REMARKS

Amendments to the drawings**In the Drawings:**

Proposed amendments to FIG. 1-4 and 7 are provided herewith. Enclosed are 5 sheets of Annotated Mark-Up Drawings and 5 sheets of clean as-amended Replacement Sheets, wherein FIG. 1-3 have the text “(Prior art)” added, FIG. 4 has the text “(Background art)” added, and FIG. 7 has the reference 20 replaced with the reference 68.

FIG. 1

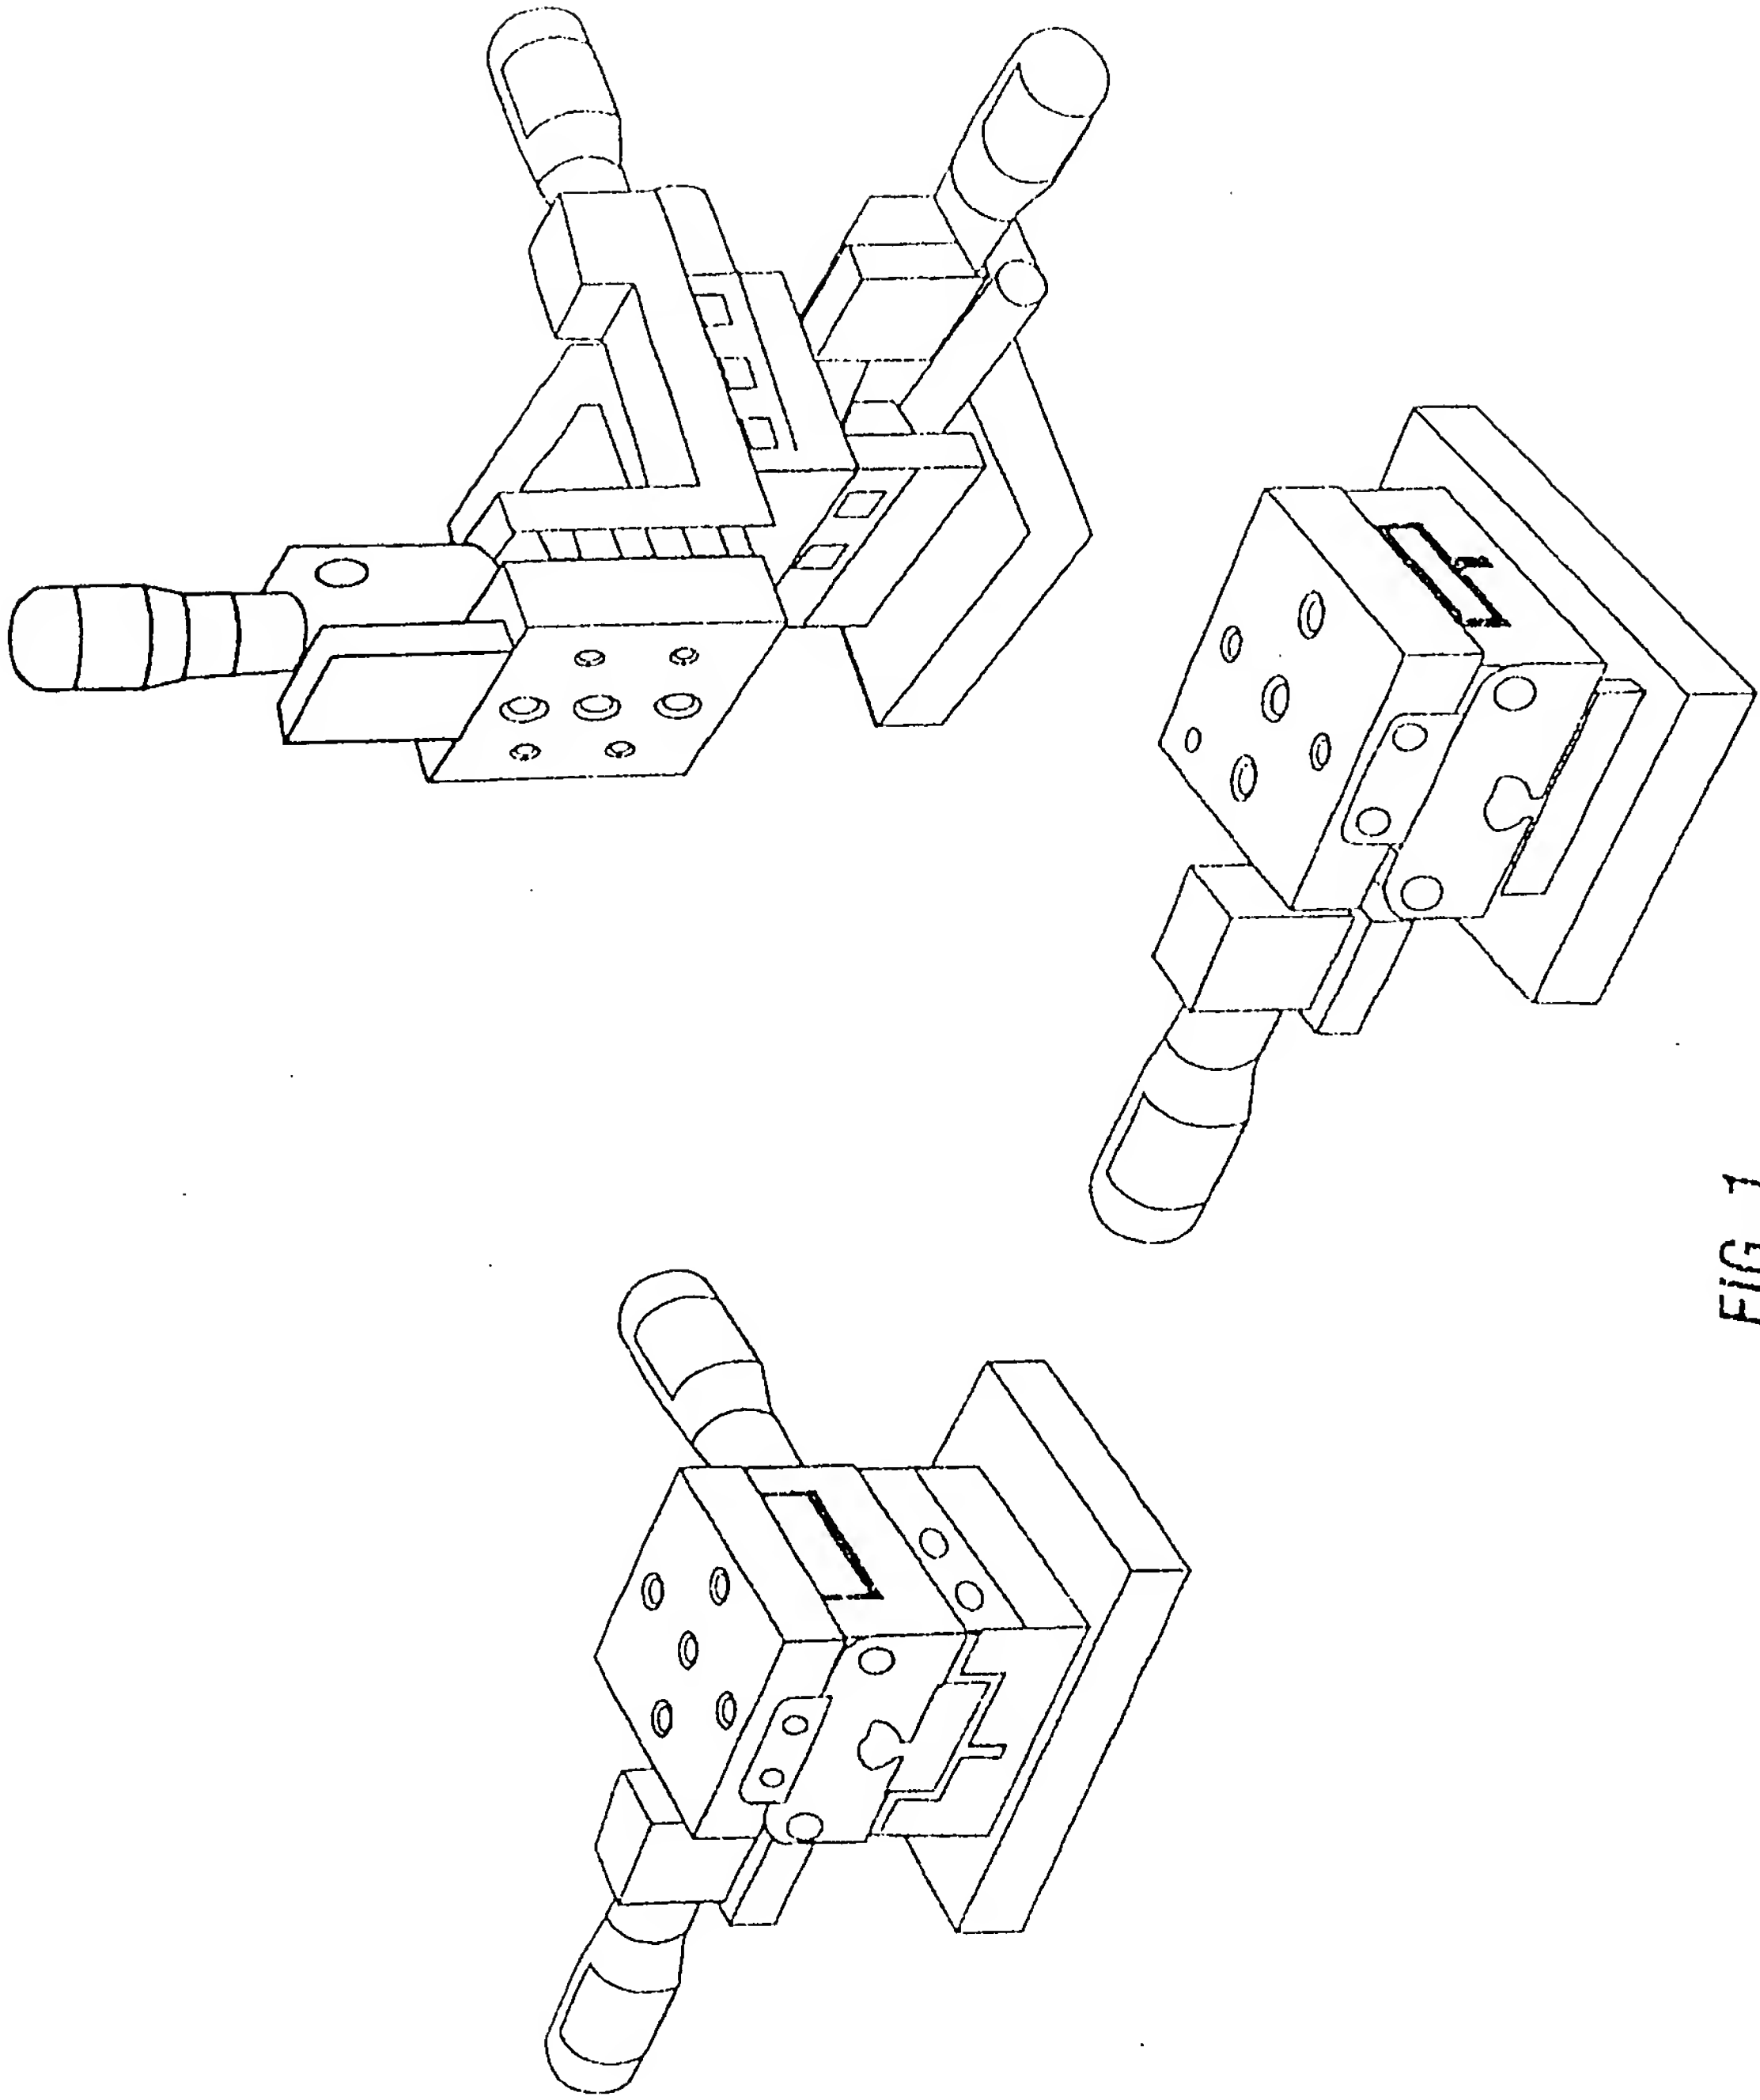
We respectfully ask entry of the proposed amended versions of FIG. 1-4 enclosed herewith. As filed, FIG. 1-3 inadvertently failed to include the text “(Prior art)” and FIG. 4 inadvertently failed to include the text “(Background art).” These amendments will bring the figures into conformity with the text in paragraphs [0014]-[0017] of the specification.

Added

FIG. 2

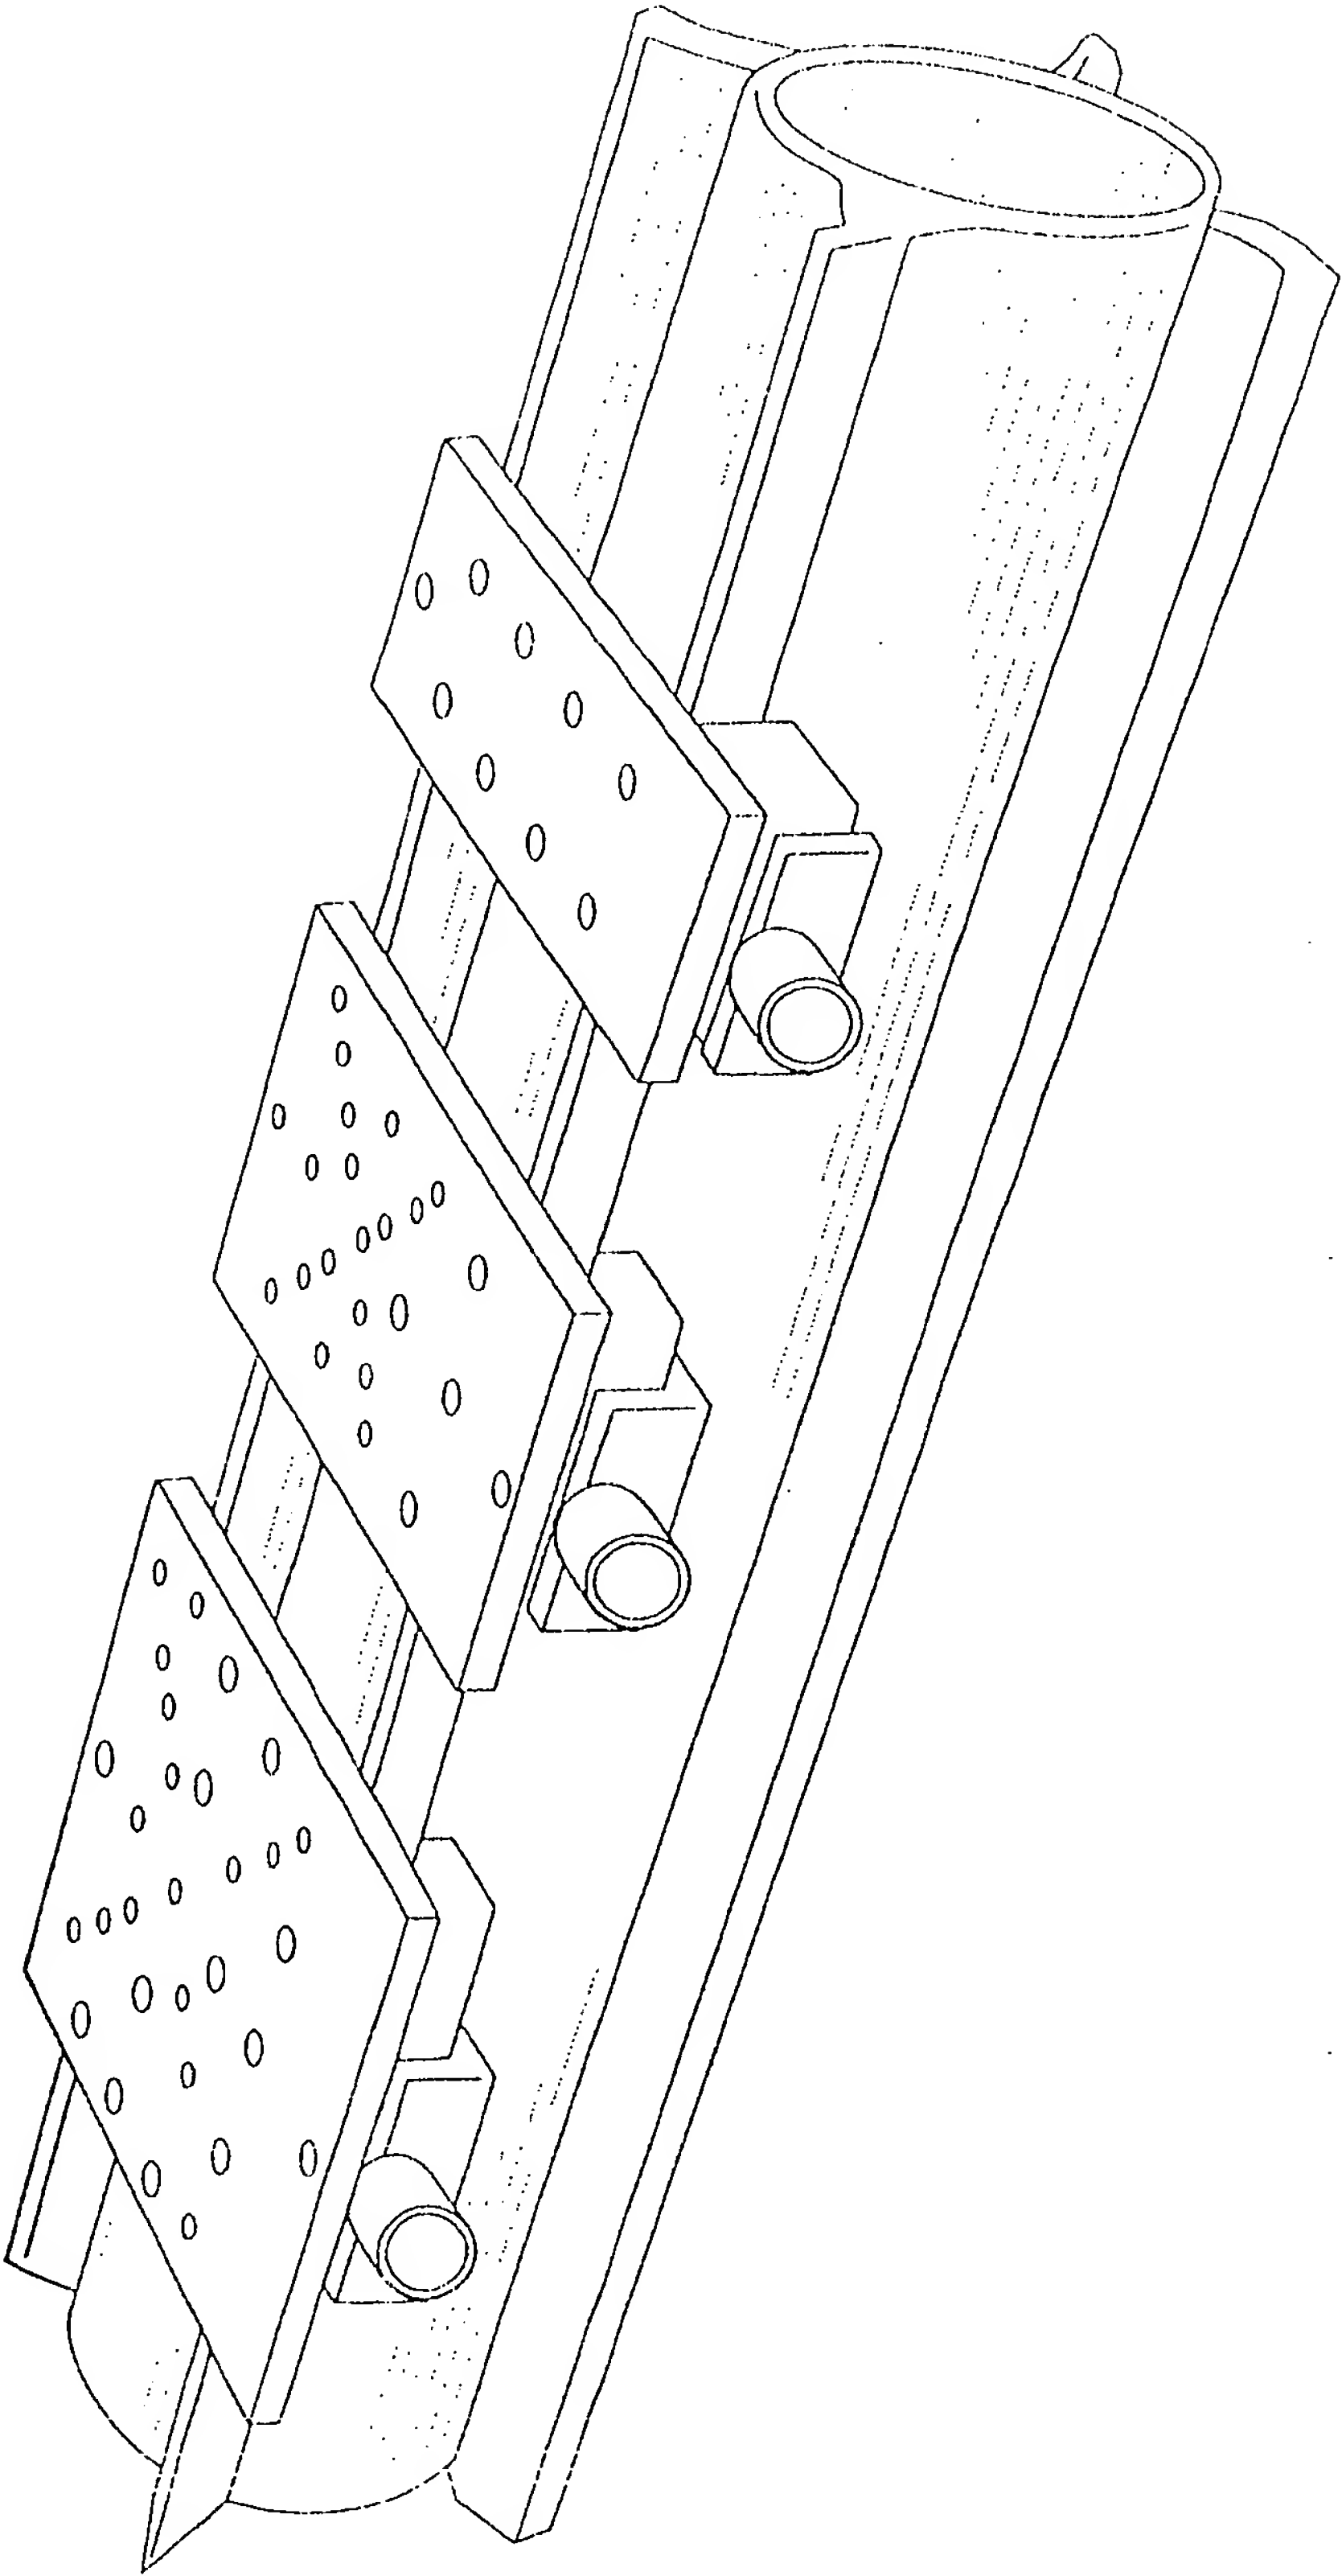
Turning now to claim 4, it recites “*a plurality of said stages and at least two said stages include a same said first piece and share a same said digital scale.*” FIG. 2 (Prior art) clearly shows multiple stages sharing a mount, thus the mechanical aspects here would be understood by one of ordinary skill in the art. FIG. 5a-b, 6 and 7 show a digital scale, thus it would be understood by one of ordinary skill in the art what a “*same said digital scale*” is. And we further note that 37 CFR 1.83(a) does not require that drawings odiously show every possible straightforward variation feature of an invention, rather this states that “*applicant ... is required to furnish a drawing ... where necessary for the understanding of the subject matter sought to be patented.*” Respectfully, we urge that Applicant has shown what is necessary for one of ordinary skill in the art to understand claim 4.

What has been missed here, however, is the overall context and the tension between common spoken English and the need for antecedent basis in claims. Claim 4 (now) recites “a plurality of said stages and at least two said stages include a same said first piece” (underlining added). In common spoken English one would simply say that two of the stages include the same first piece. We previously (in claim 1) introduced “a first piece” so it is our understanding under the antecedent basis rules that use of the phrase “said first piece” is required here in claim 4. Also, here we have multiple stages (each having a respective said first piece) and we need to introduce “a same said first piece,” which is one first piece that is common (the same) to two stages. By way of example, FIG. 2 shows three stages all sharing one first piece (the tubular appearing mount).

Added
